CITY OF RAMSEY LAND USE APPLICATION
TECHNICAL REVIEW FILE

DATE	MAY 12, 2017 REVISED: JUNE 16, 2017	PROJECT ADDRESS	TBD
PROJECT. TITLE	ESTATES OF SILVER OAKS 2 ND ADDITION		
ESCROW #	115698		
DEPARTMENT:	Community Development: Planning Division (Landscape Plan & Environmental Resources)		
TECHNICAL REVIEWER:	Name: Chris Anderson, City Planner Phone: 763-433-9817 Email: canderson@cityoframsey.com

Review File: Estates of Silver Oaks 2nd Addition

Preliminary Plat: Landscaping

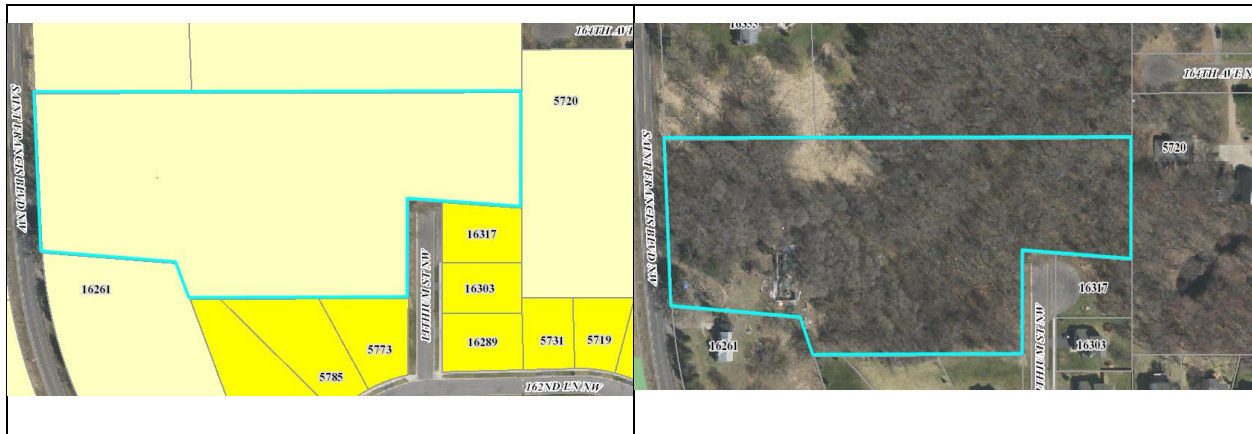
Approximately fifty-three percent (53%) of the existing significant tree inches will be preserved on site. Although essentially all of these trees are located on what will become Lot 5, Block 2, the Tree Plan does comply with the Tree Preservation Ordinance.
